14 August 2024

ASPECT INDUSTRIAL ESTATE MODIFICATION 6 (SSD-10448 MOD 6) & STAGE 4 DEVELOPMENT (SSD-60513208) - RESPONSE TO REQUEST FOR ADDITIONAL INFORMATION WAREHOUSE 8

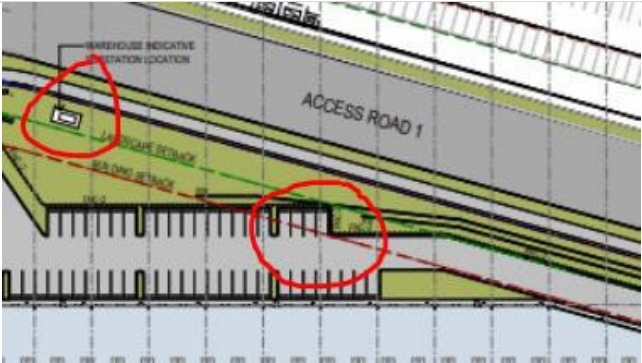
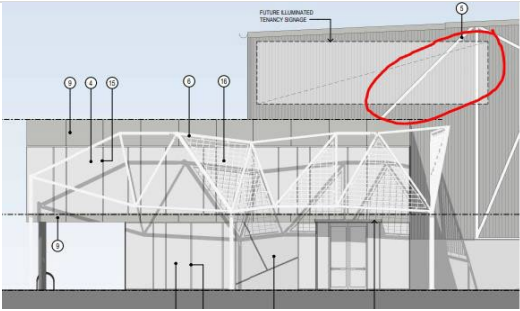
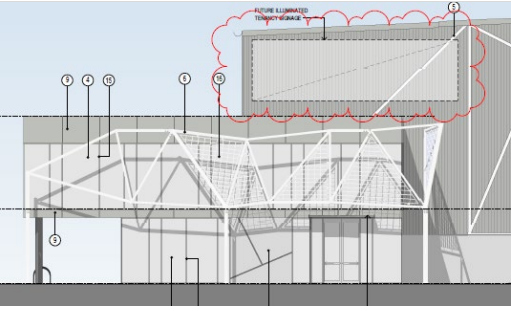
c) The setback of the fire trail access behind the building setback zone (facing Mamre Road) is an improved outcome.	Noted.
d) The indicative location of the substation fronting Access Road 1 should remain behind the landscaped setback area (see snippet below).	The ultimate location of the substation will be confirmed in a collaborative effort between Mirvac, Edgewater Connections and Endeavour Energy in accordance with the maintenance / operational requirements. The location of the substation fronting Access Road 1 will be supported by a landscape led approach as part of the detailed design phase.

<p>e) The additional car parking spaces near Access Road 1 appear to be very close to the line of the landscaped setback (see snippet above).</p> <p>f) Given that the proposed modifications would result in 18 additional spaces above the DCP minimum, it is questionable whether the spaces near the landscaped setback are needed. DPFI should ensure that these additional spaces do not impinge of the landscaping in the setback area.</p>	<p>The proposed parking provision seeks to future-proof the warehouse for the potential tenant operations across the large-form warehouse structure. As shown in the snippet above, the carparking remains behind the landscape setback.</p>
<p>g) Any proposed signage on the upper sections of the warehouse facades should not obscure the perforated metal screens used to provide articulation (see snippet below). While signage in the general position as shown is acceptable, the sign should be better incorporated and subservient to the decorative metal screen pattern.</p>	<p>Refer to Attachment A - Architectural Drawings Warehouse 8_31.07.2024. An updated elevational drawing has been prepared to better integrate the proposed signage on the warehouse façade. The signage area on the east facade has been pulled away from the vertical features to the right of the sign. An extract is provided below of the updated signage layout.</p>

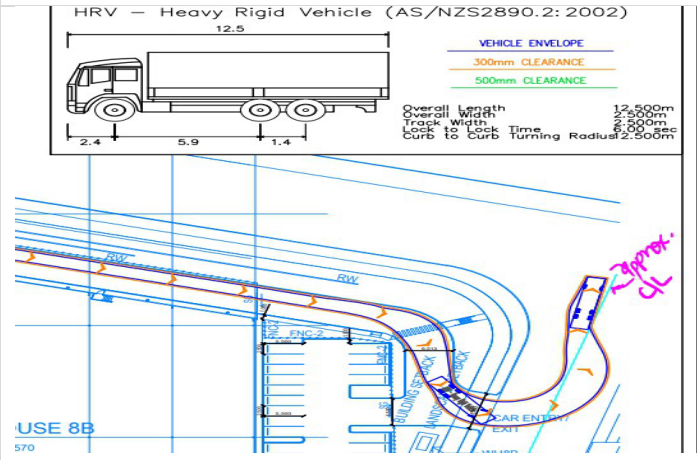
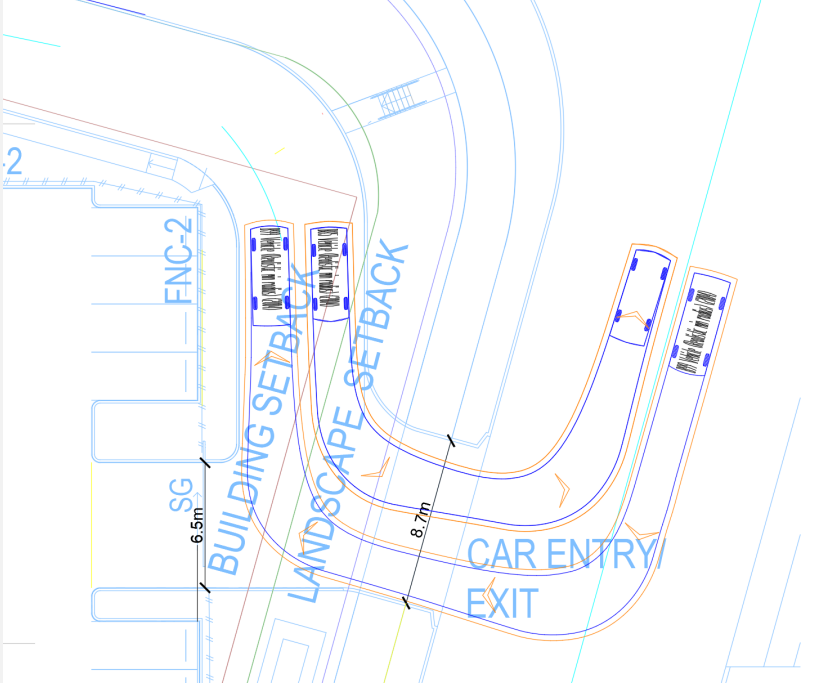
<p>One of the swept paths indicate heavy rigid vehicles (HRVs) encroach the centreline of Road 4 while exiting Lot 8 using the carpark access which is not acceptable. Subject to satisfactory swept path diagrams, this vehicular access may only be suitable for B85, B99 and SRVs.</p>	<p>The HRV swept path was undertaken as a checking vehicle exercise to account for emergency vehicles (e.g. fire appliances) circulating the perimeter of the warehouse building under occasional conditions. The car park access has been appropriately sized for day-to-day use by light vehicles (see below response), which in turn discourages trucks from entering the car park.</p> <p>The swept path analysis of the HRV demonstrates that sufficient geometry is provided to accommodate emergency vehicles and it is</p>

acceptable for fire appliances to cross the centre of the access road also noting that this will be an unmarked carriageway.
